EXISTING CONDITIONS and
DEMOLITION PLAN
1701 DISCIPLE DRIVE
JONESBORO, ARKANSAS
FOR
JOURNEY CHURCH

GRADING and DRAINAGE PLAN
1701 DISCIPLE DRIVE
JONESBORO, ARKANSAS
FOR
JOURNEY CHURCH

JOURNEY JONESBORO CHURCH
KIDS' EXPANSION
1701 disciple drive - jonesboro, ar 72401

**JOURNEY JONESBORO CHURCH
CLASSROOM ADDITION**
1701 disciple drive - jonesboro, ar 72401

FLOOR PLAN -
POWER AND AUX. SYST.

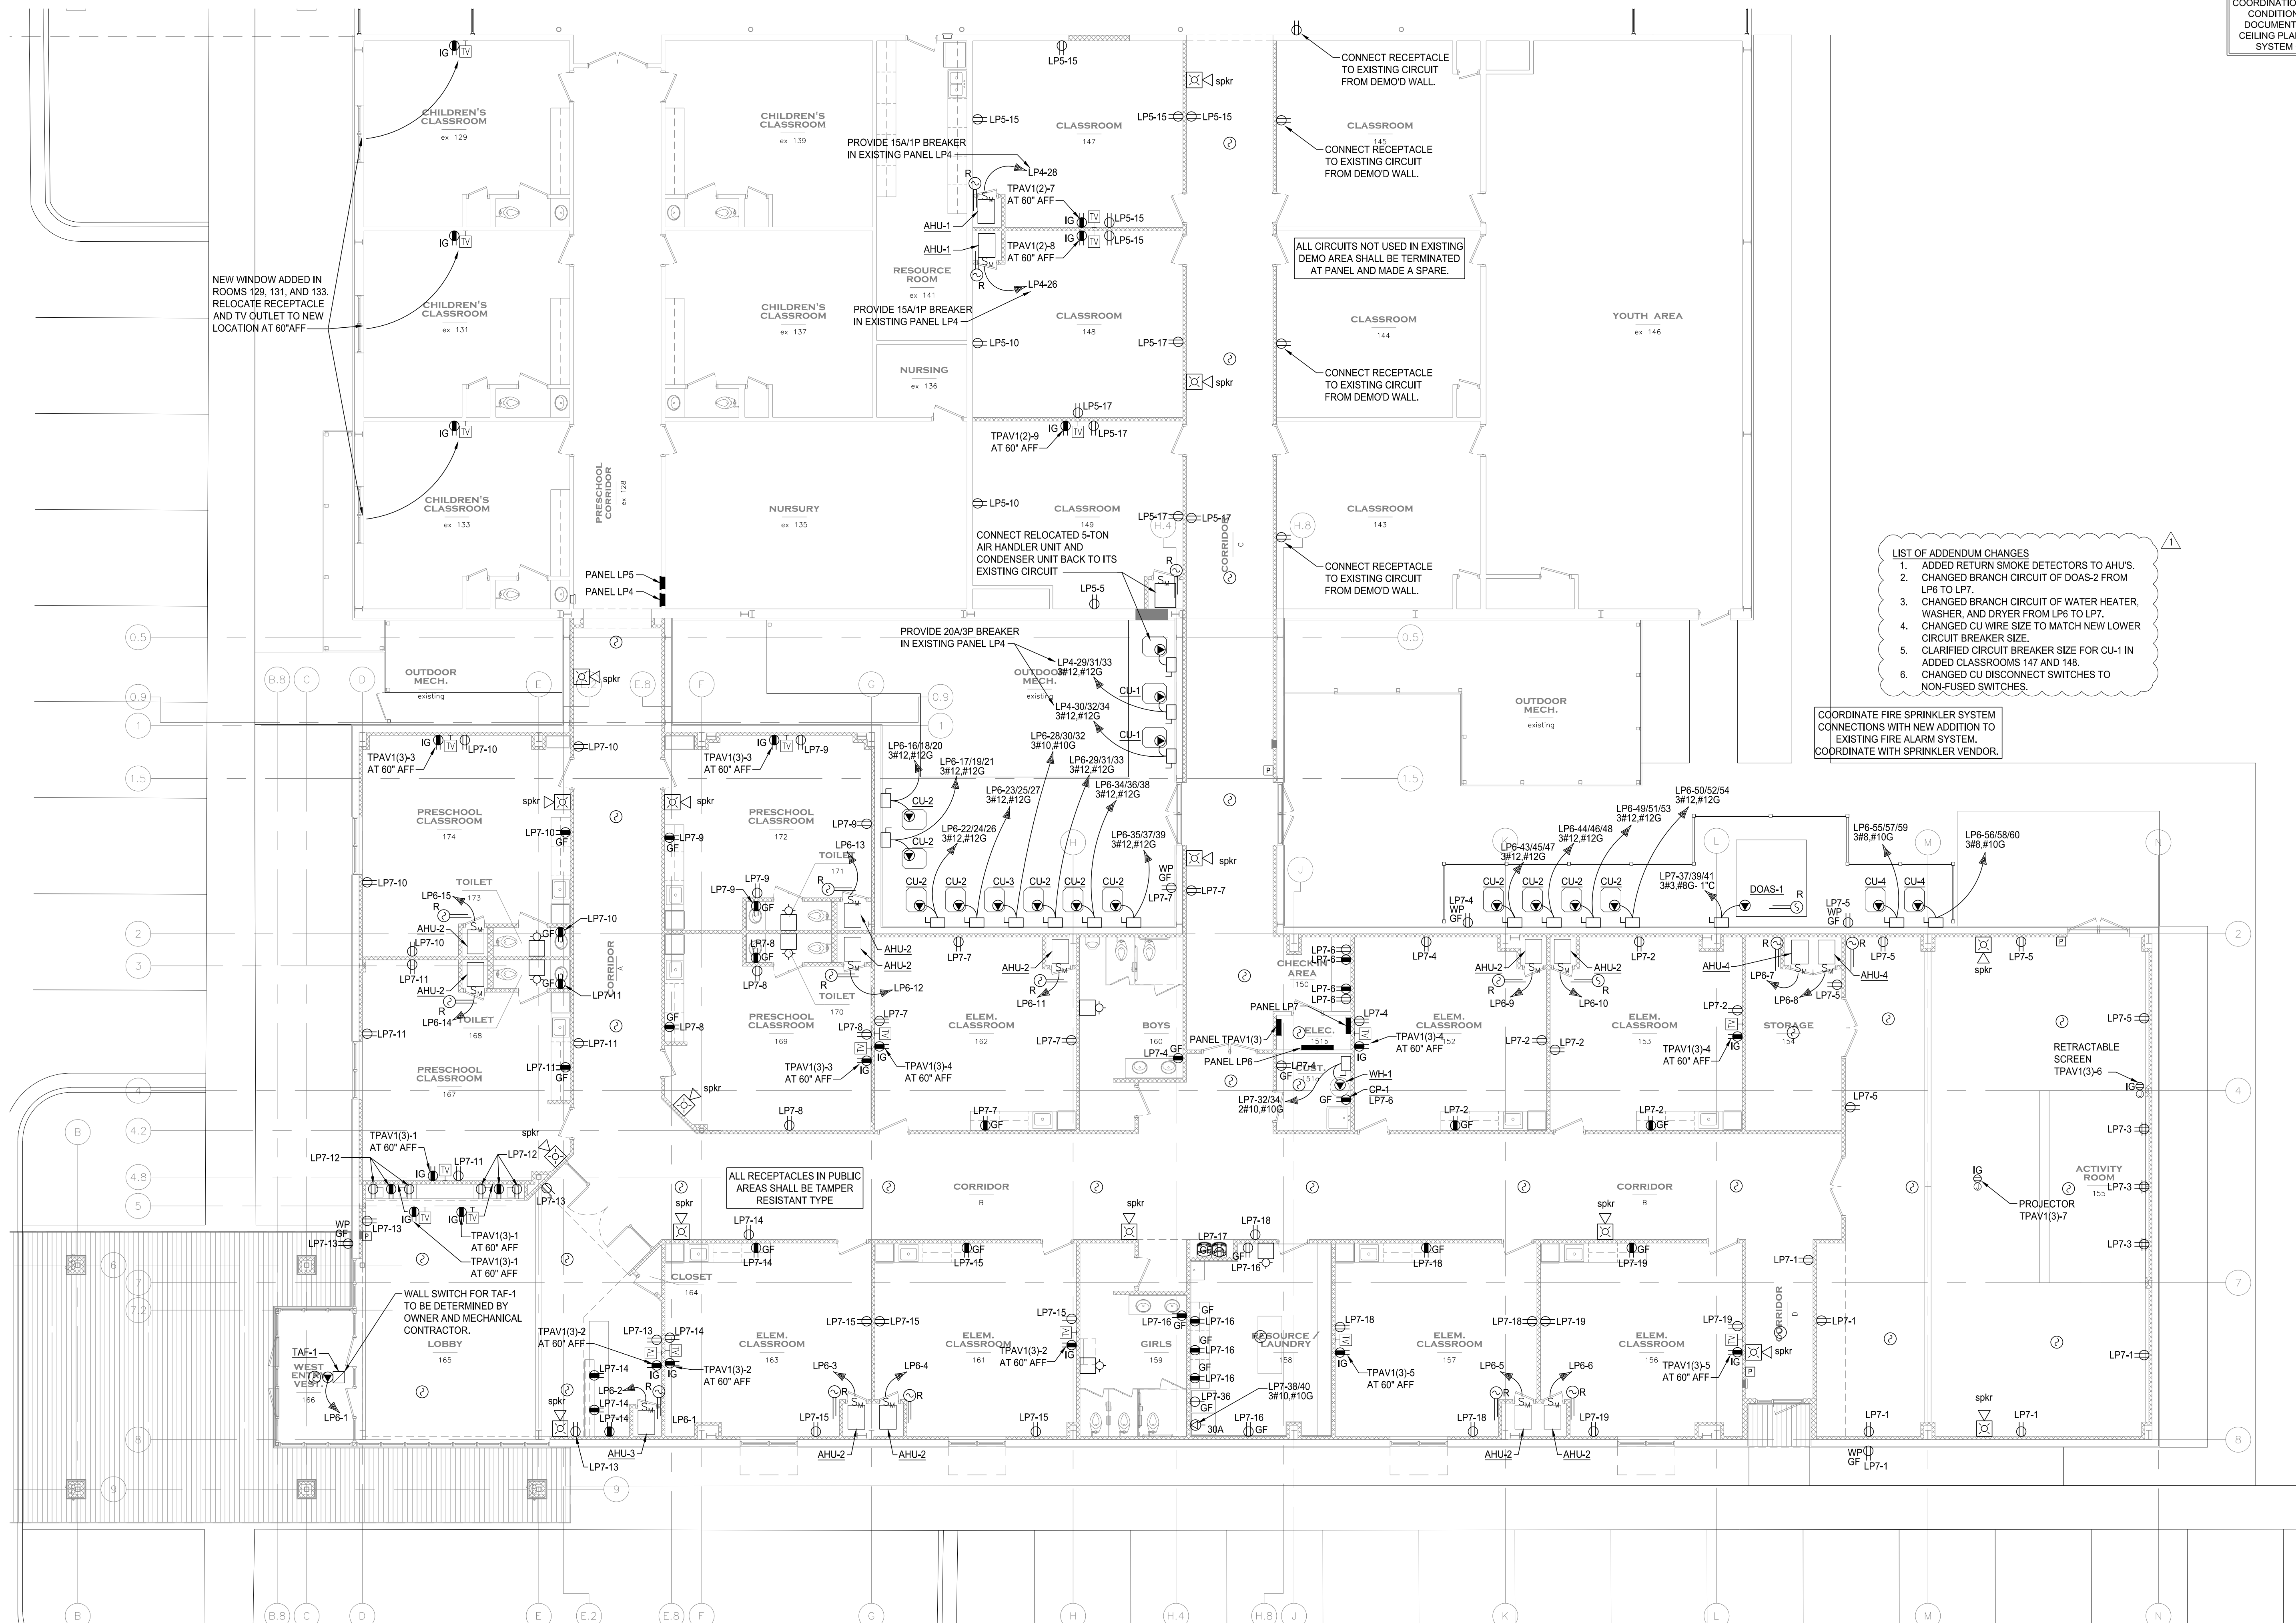
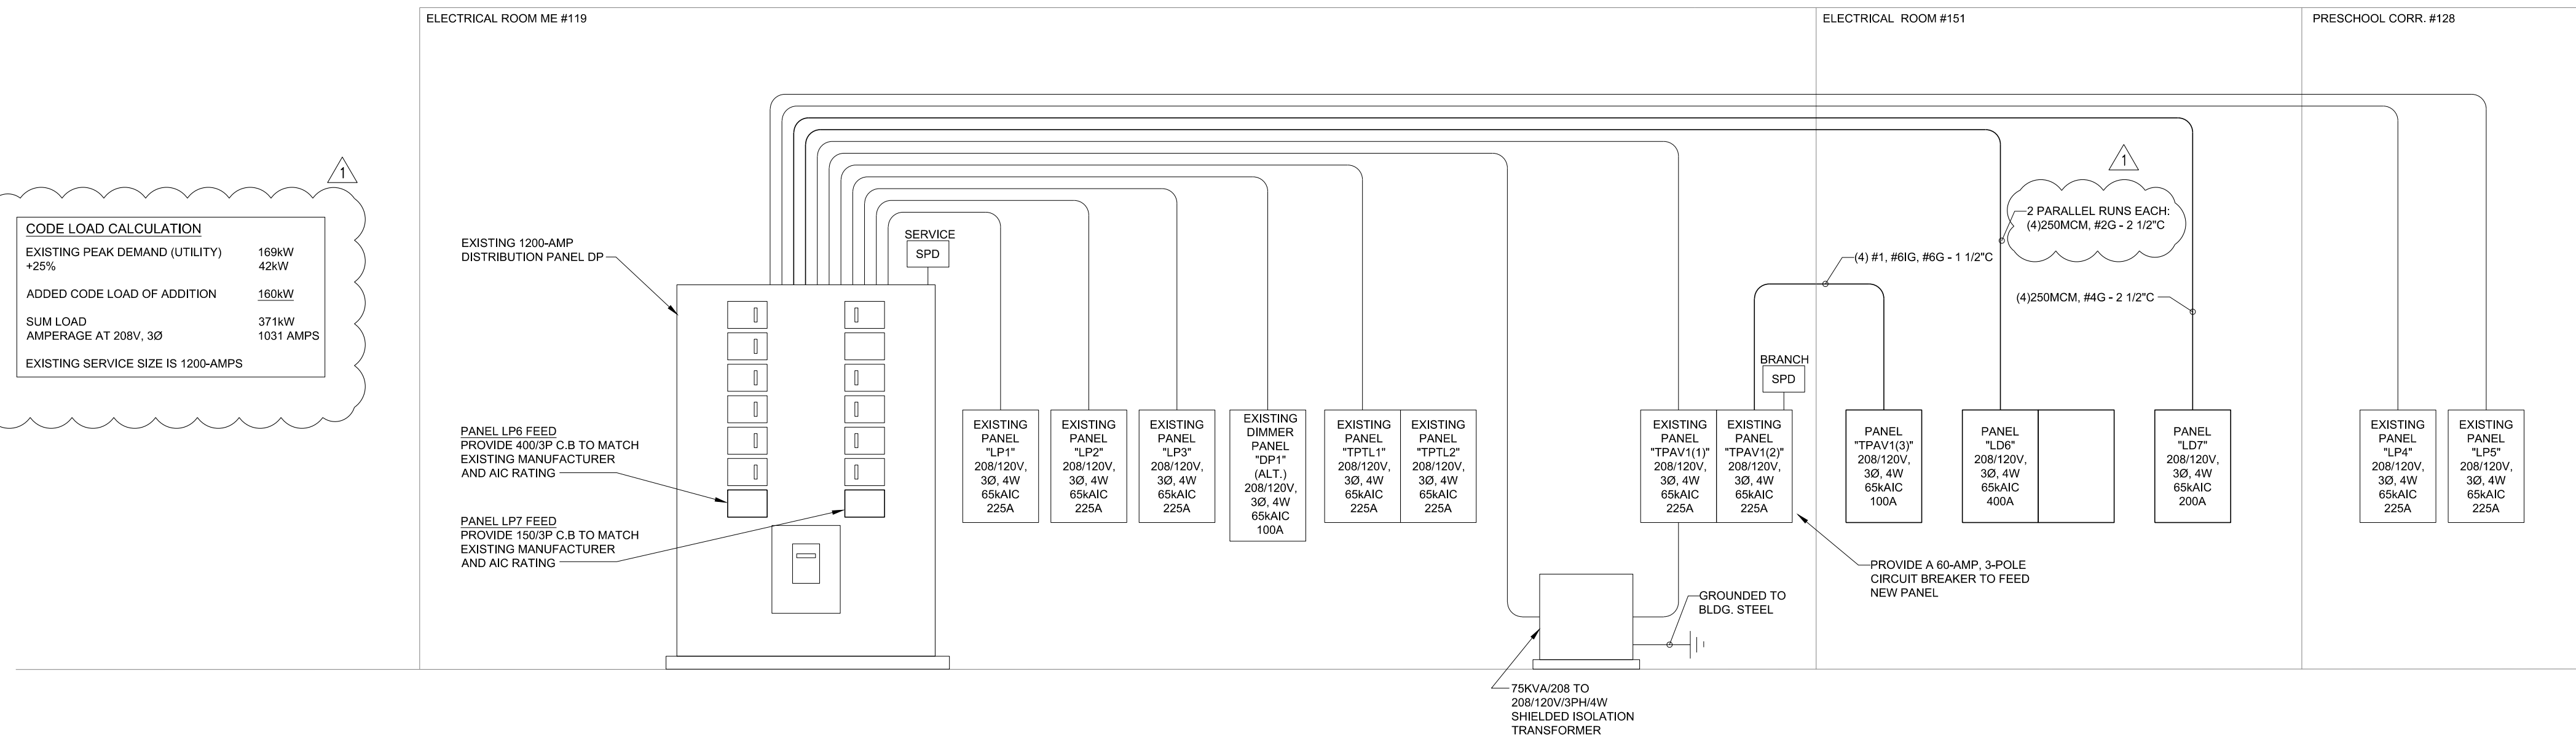
- LIST OF ADDENDUM CHANGES
1. ADDED RETURN SMOKE DETECTORS TO AHU'S.
 2. CHANGED BRANCH CIRCUIT OF DOAS-2 FROM LP6 TO LP7.
 3. CHANGED BRANCH CIRCUIT OF WATER HEATER, WASHER, AND DRYER FROM LP6 TO LP7.
 4. CHANGED CU WIRE SIZE TO MATCH NEW LOWER CIRCUIT BREAKER SIZE.
 5. CLARIFIED CIRCUIT BREAKER SIZE FOR CU-1 IN ADDED CLASSROOMS 147 AND 148.
 6. CHANGED CU DISCONNECT SWITCHES TO NON-FUSED SWITCHES.
